Arlington County Historical Affairs and Landmark Review Board, Design Review Committee
January 2024 Pre-Meeting Letter

REQUESTED REVISIONS TO HALRB CERTIFICATE OF APPROPRIATENESS
17 March 2021, Case 19-27A (HPCA21-00007)

**WALKER CHAPEL HISTORIC CEMETERY PROJECT (HCP)
RE-INSTALLATION OF SITE ELECTRICAL EQUIPMENT**

OPTION 5: NEW PROPOSAL

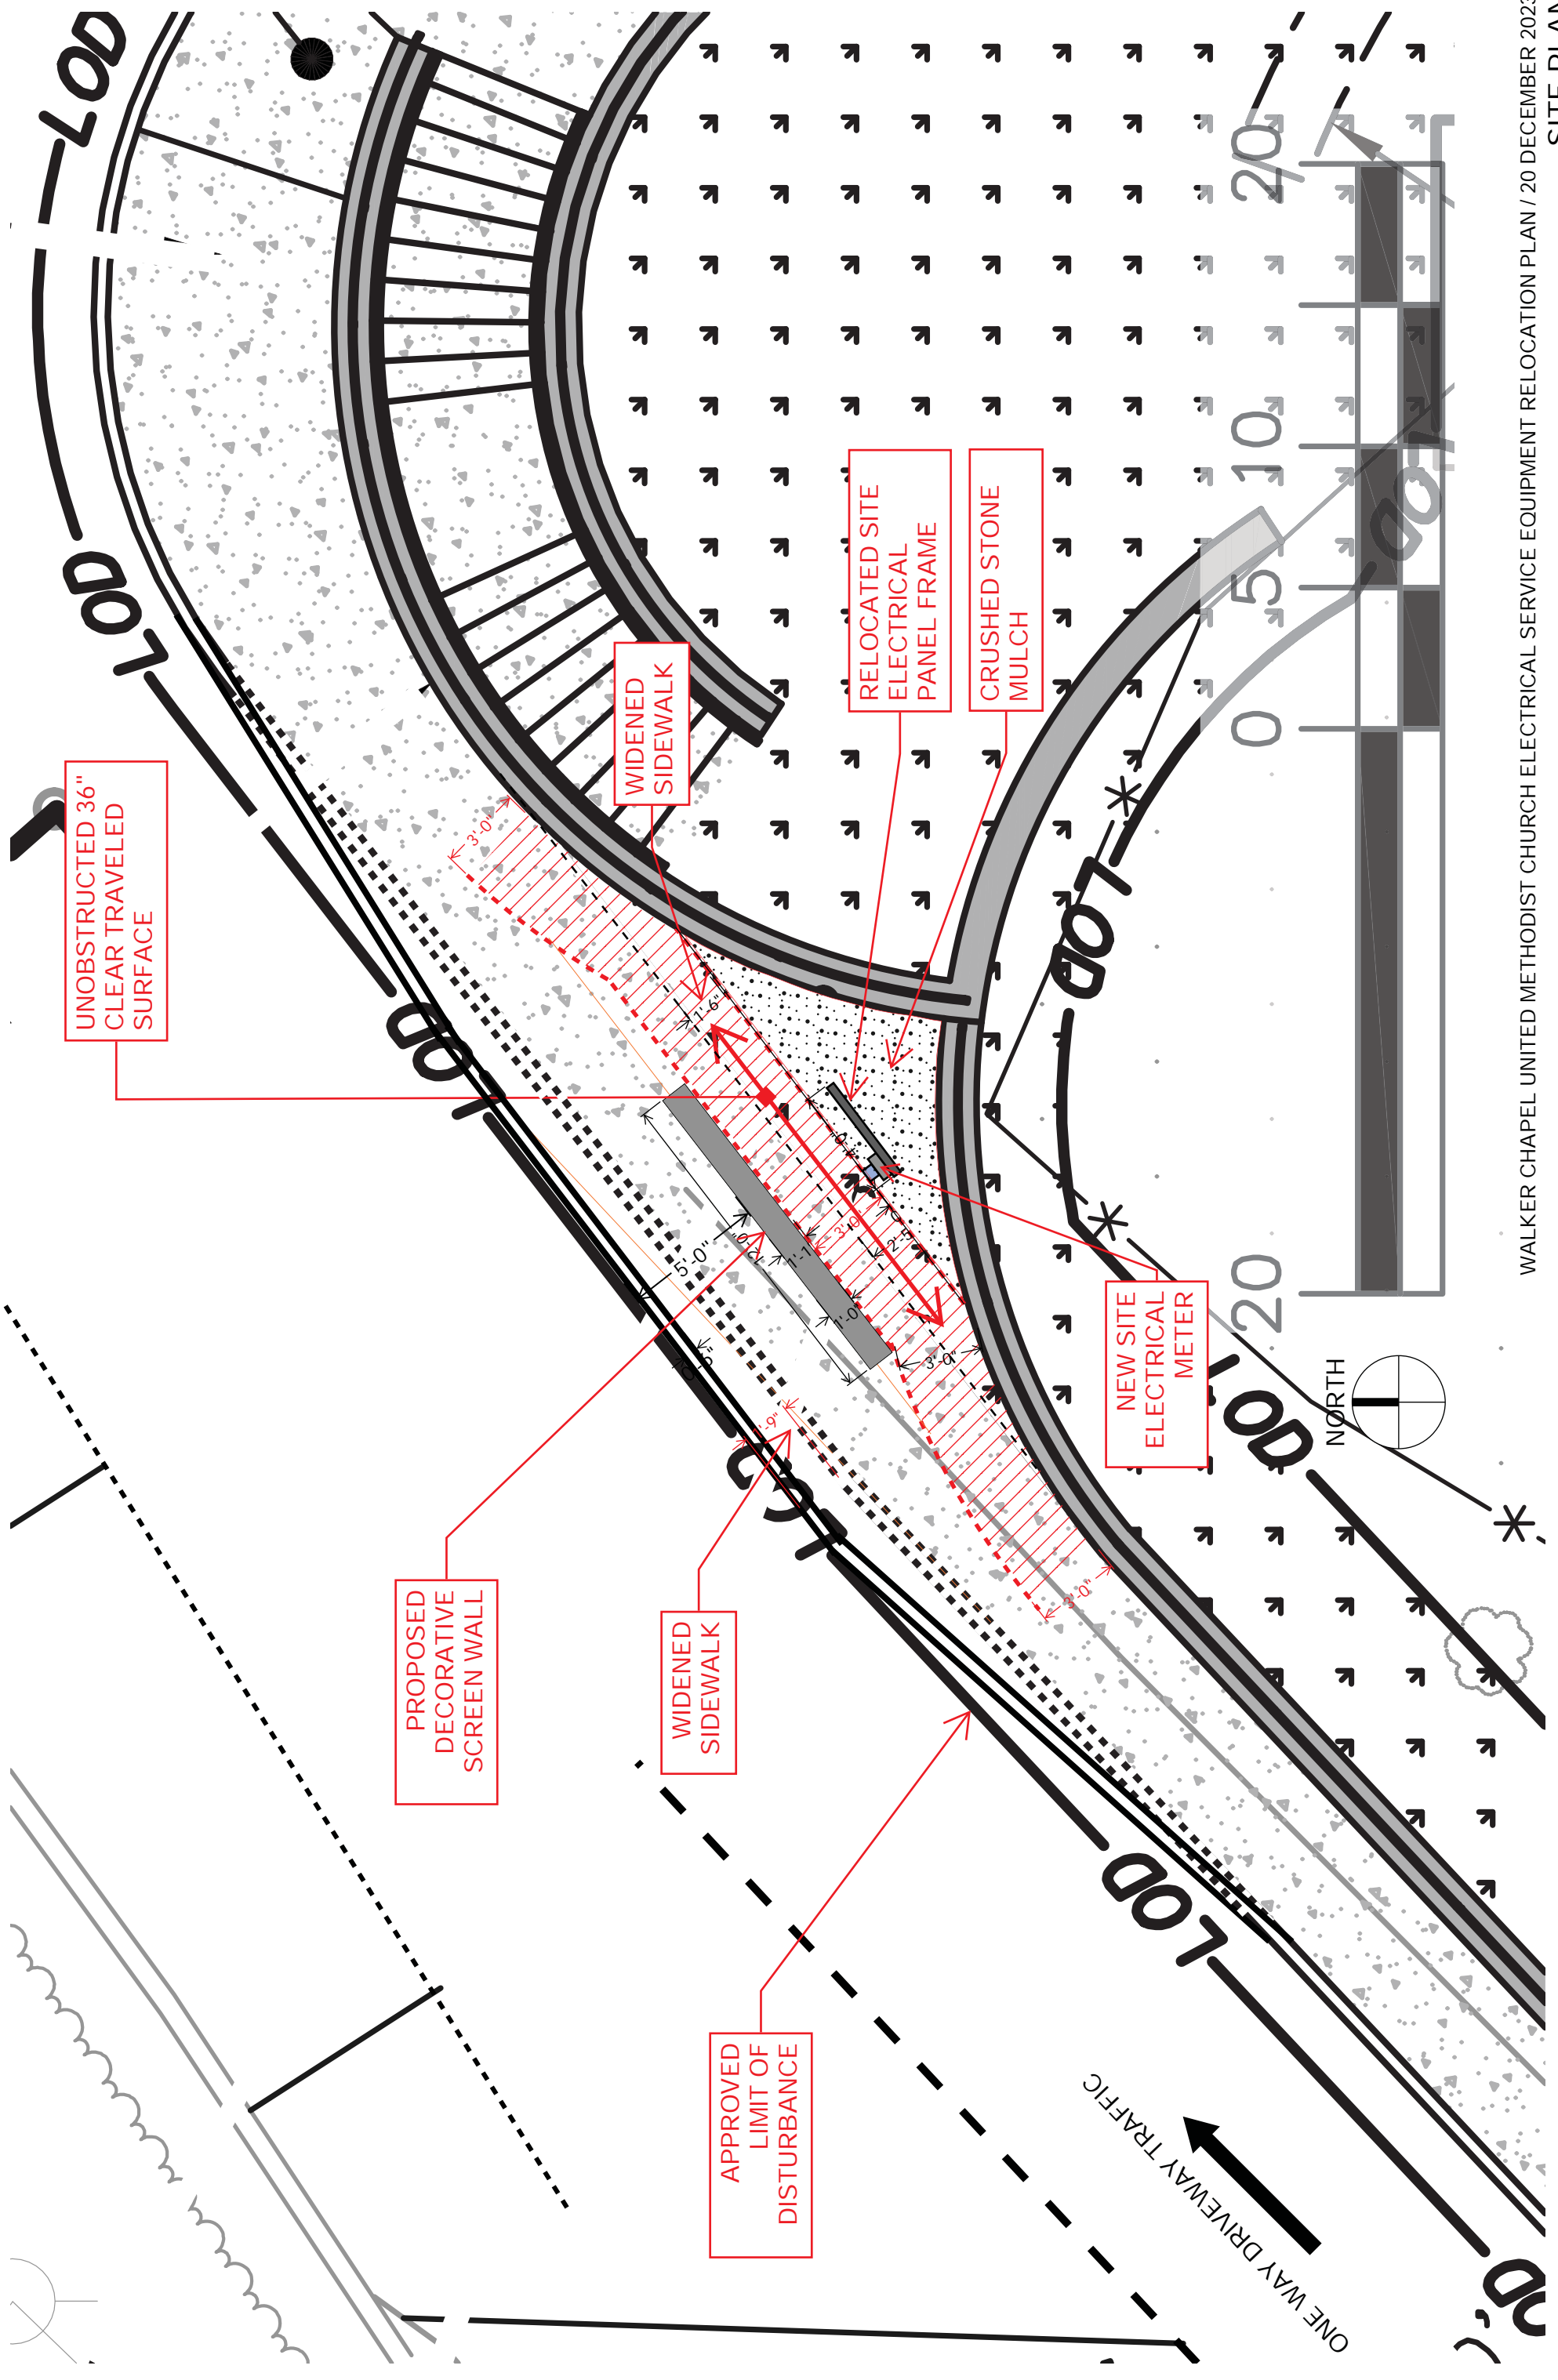
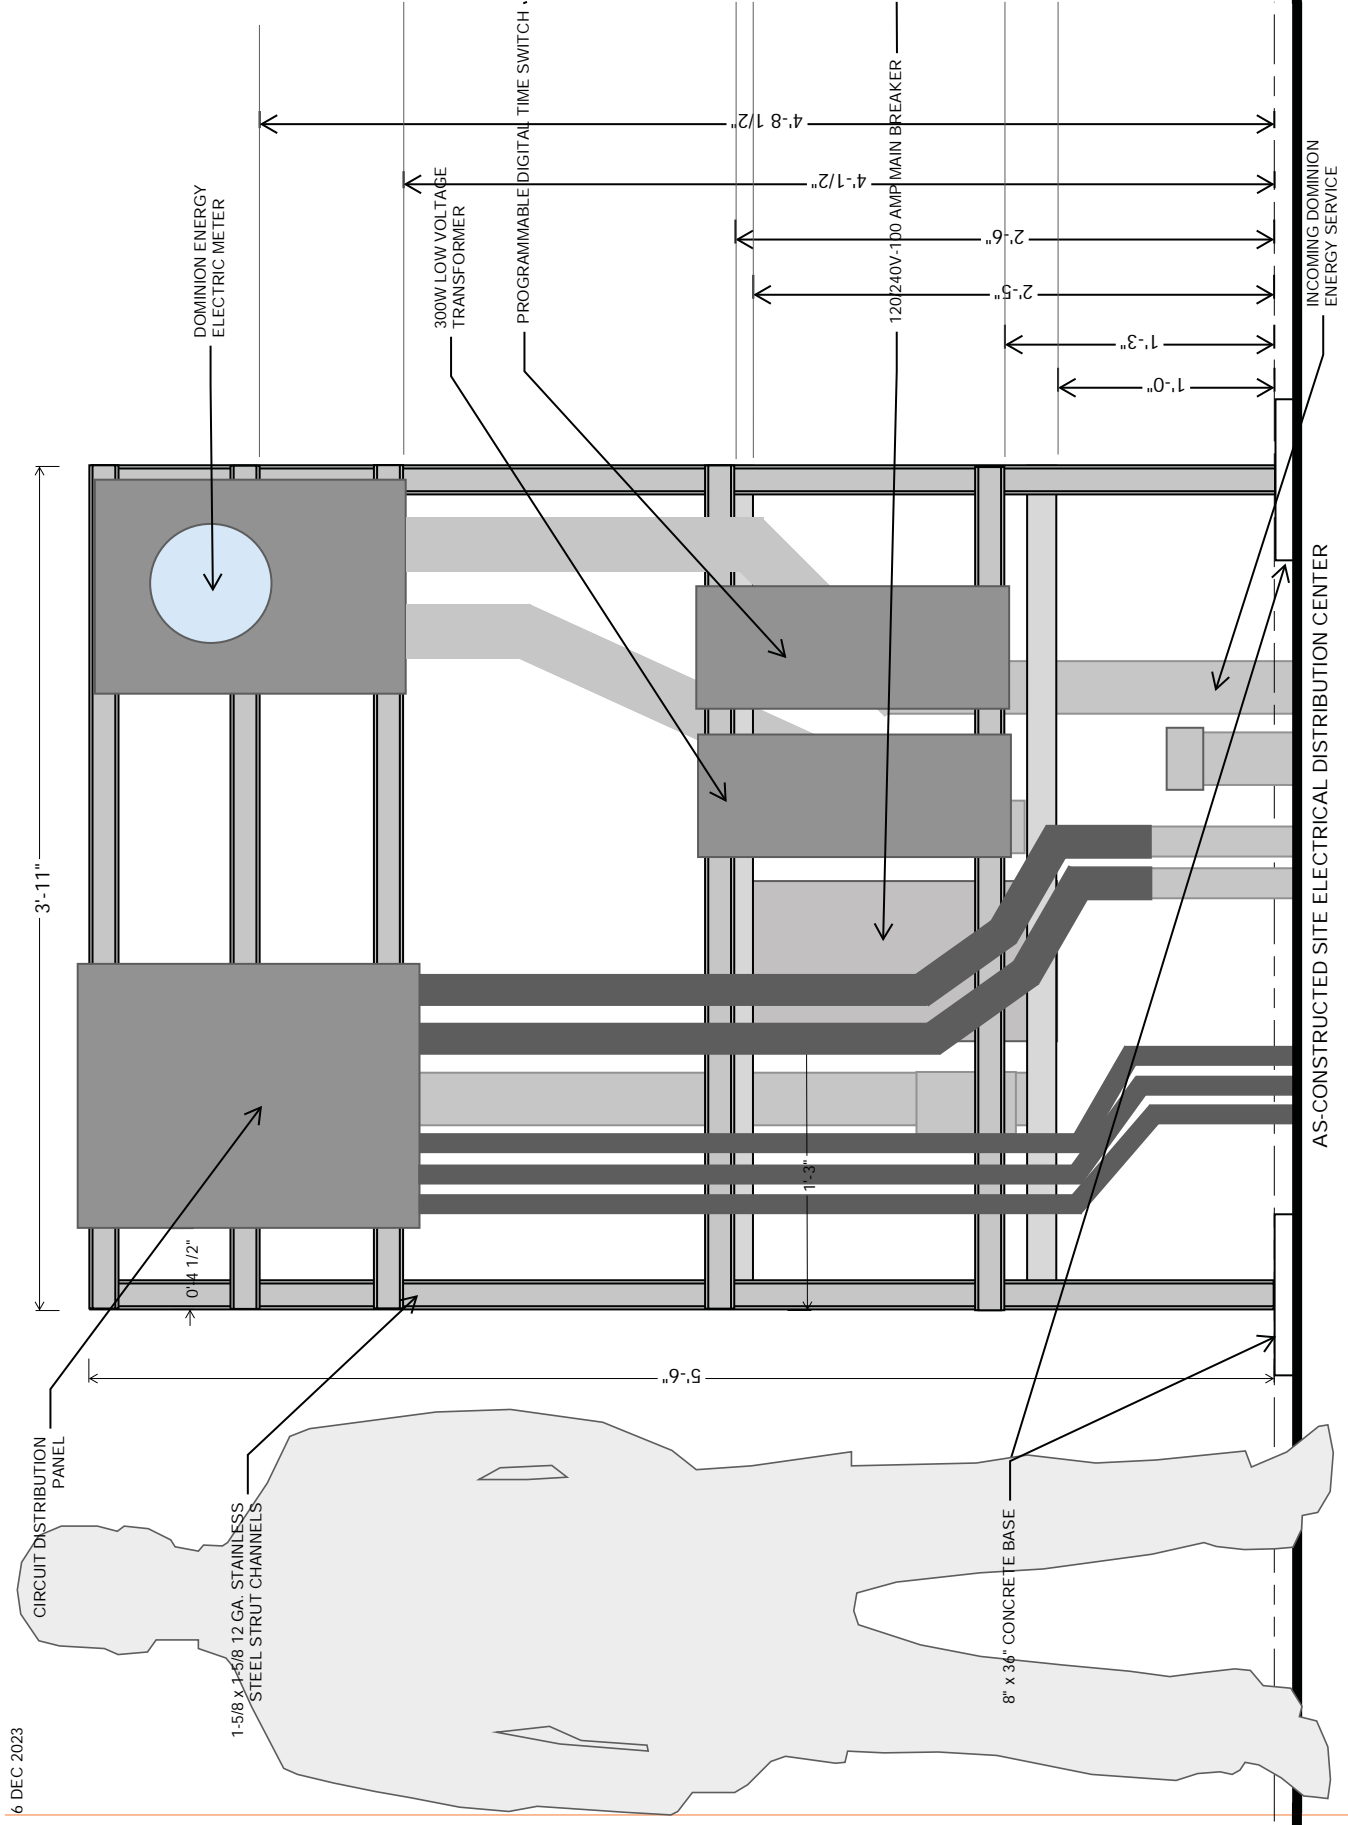
Under Dominion Energy design criteria, it is virtually impossible to completely screen the site electrical equipment. Given the questionable effectiveness of a severely limited screening approach, Walker Chapel requests HALRB acceptance of the as-constructed condition as it is not visible from off-site public views.

It should be possible to lessen the visual impact of the as-constructed electrical gear with a partial screen device that offers its own attention-getting quality, making the exposed electrical gear secondary in nature.

The following approach complies with Dominion Energy's electric meter physical clearances. Furthermore, nothing is attached to the site electrical support frame other than the meter and related electrical panel boxes--therefore, the proposed screen wall should not be reviewable by Dominion Energy.

Option #4

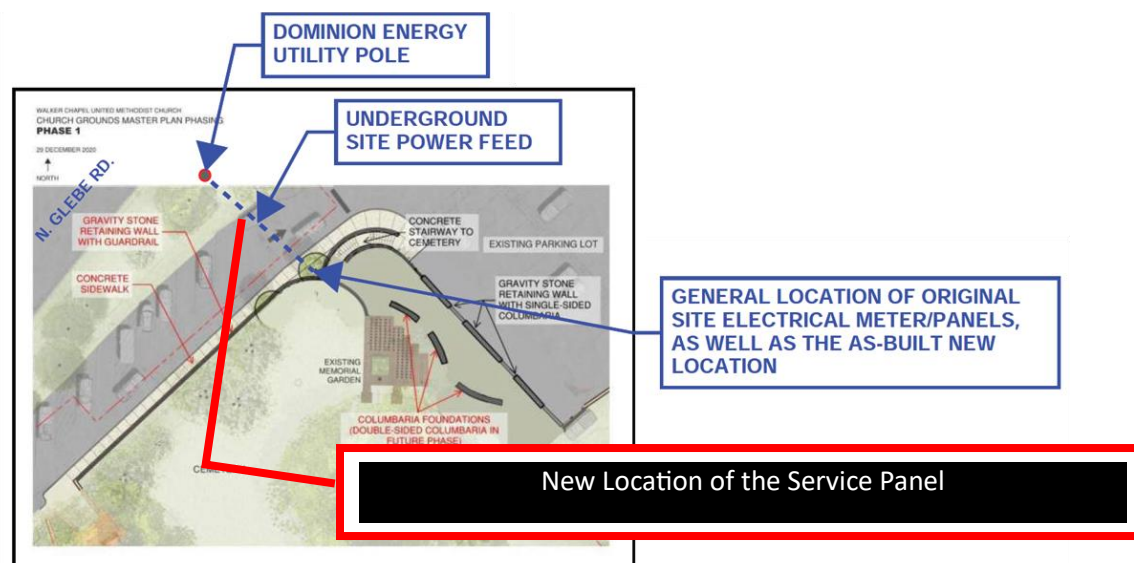
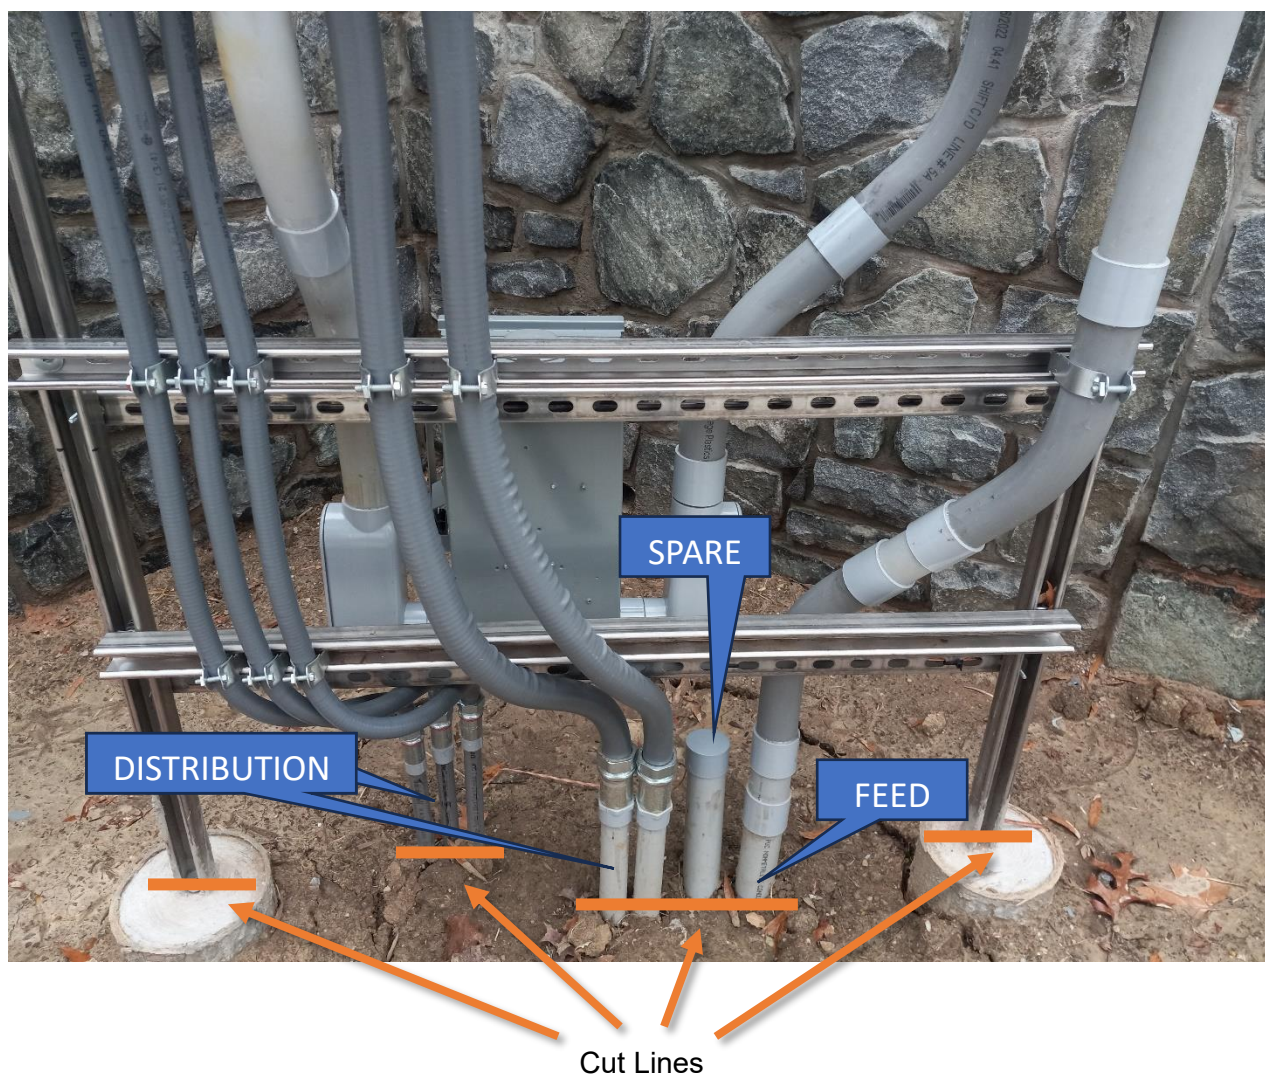
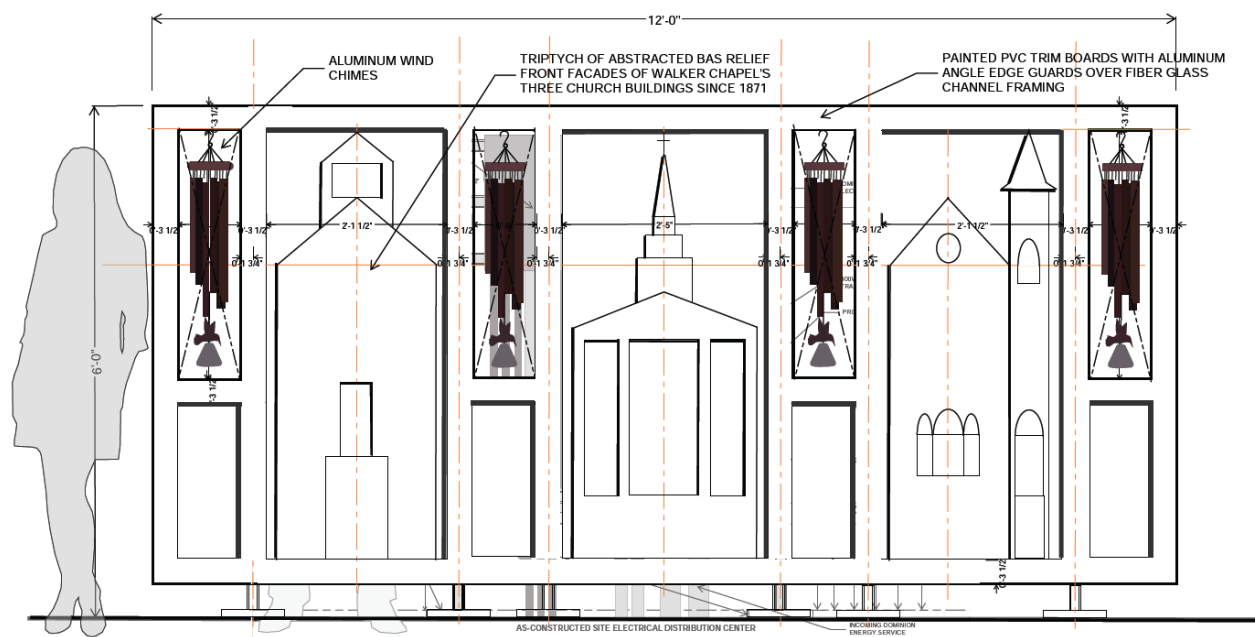
The only solution that has no issues, is acceptable to everyone and does not deface the historic cemetery is to locate the service panel away from the cemetery. The recommended location is on the line of the underground site power feed but across the driveway from the cemetery.

1. The asphalt is only a few inches thick at this point,
2. The conduit for the power feed is within a short distance below the surface,
3. The main feed line only needs to be cut to size...not re-pulled.

4. The existing large conduit under the driveway can easily accommodate the much lighter distribution wires to the electrical fixtures (in fact, there are two conduit runs and one is an empty spare),

5. The existing light gauge distribution wires can easily be placed in a quazite box on the cemetery side of the driveway and spliced into new wires pulled across and under the road,

6. There would be 360-degree access to the components that exceeds Dominion Electric's distance requirements,
7. The meter height can be set exactly to Dominion Electric's requirements,

8. The location is out of the line of traffic and there will be no loss of parking places,
9. It provides a large space to install the triptych, and
10. The entire rack can be protected with two bollards sunk vertically into the ground and filled with concrete.

1. Remove the asphalt in the new location,
2. Use the auger to dig two new holes and insert in concrete two new 4" vertical rails; 3' below ground and 1' above ground,
3. Cut the existing rack and conduits at ground level as shown below in orange,
4. Move the rack in one piece to the new location and bolt the rack vertical pieces to the new 4" vertical supports,
5. Redo the conduit to fit cutting the main feed line to fit and pulling new distribution lines across the street using the existing buried large conduits,
6. Install a quartzite box in the current location of the rack, and
7. Connect the distribution wires.

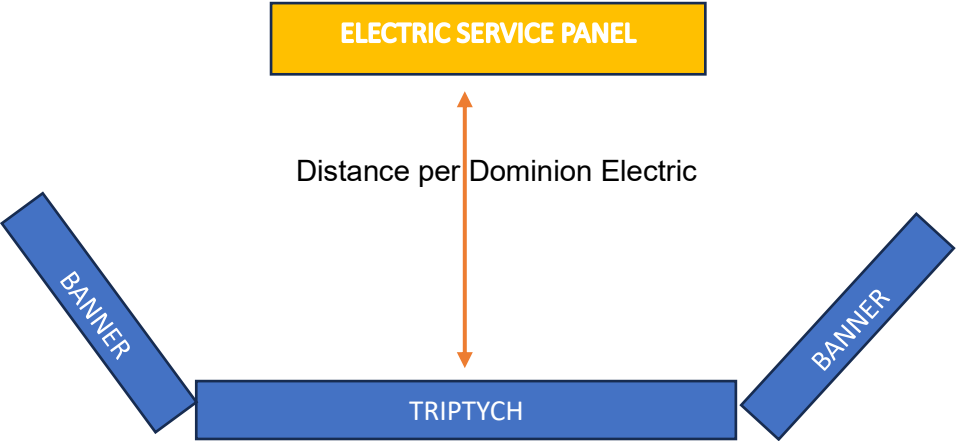
We would like to place the triptych as a screen in front of the electrical service as shown below:

We would additionally like to place two frames for hanging banners on each end of the triptych to provide a curved screen while providing needed space to promote Chapel activities. Lighting for dark days and dusk would be provided for the two banners and the triptych and controlled by dawn-to-dusk sensors with a cutoff at 10:00pm.
